SCHWEIZER SERVICE NOTICE

NOTICE NO. N-232
DATE: 06 Oct 1989
PAGE 1 OF 3

INSPECTION OF TAIL ROTOR DRIVE SHAFT DAMPER BLOCK ASSEMBLY
269A2330-3.

Figure 1. Tail rotor driveshaft and damper assembly

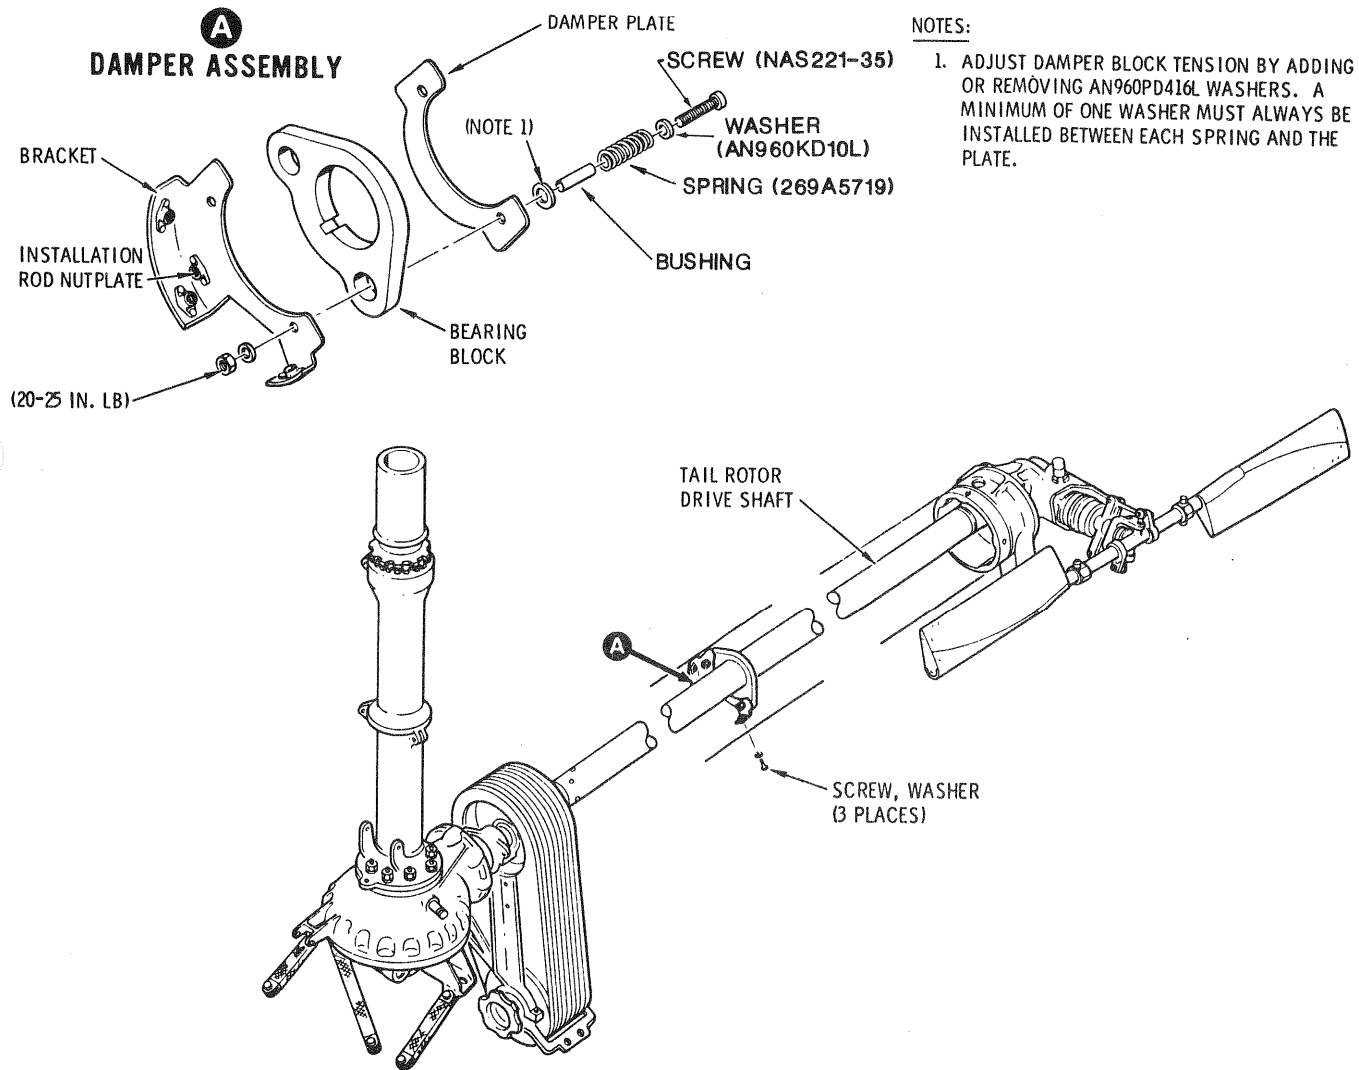
A possibility exists that washers (AN960KD10L) may not have been installed between the head of screws (NAS221-35) and tension springs (269A5719). In this event, the tension spring may slip over the screw head and cause a loss of friction on the damper block. This loss of friction may result in damper assembly damage and possible separation of the drive shaft. Failure to comply with the directives of this notice may lead to loss of aircraft control and subsequent injury or loss of life.

- a. Remove tail rotor drive shaft and damper assembly per Basic HMI, Section 10.
- b. Inspect damper assembly (Detail A, Figure 1) for installation of washers (AN960KD10L) between screw heads and springs. (If washers are installed, proceed to step e. If washers are missing, proceed to step c.)
- c. Disassemble damper assembly, as necessary to install missing washers, per Basic HMI, Section 10.
- d. Install washers, assemble damper assembly, and adjust per Basic HMI, Section 10.
- e. Install tail rotor drive shaft and damper assembly per Basic HMI, Section 10.
- f. Record compliance with this notice in compliance record of Helicopter Log Book.
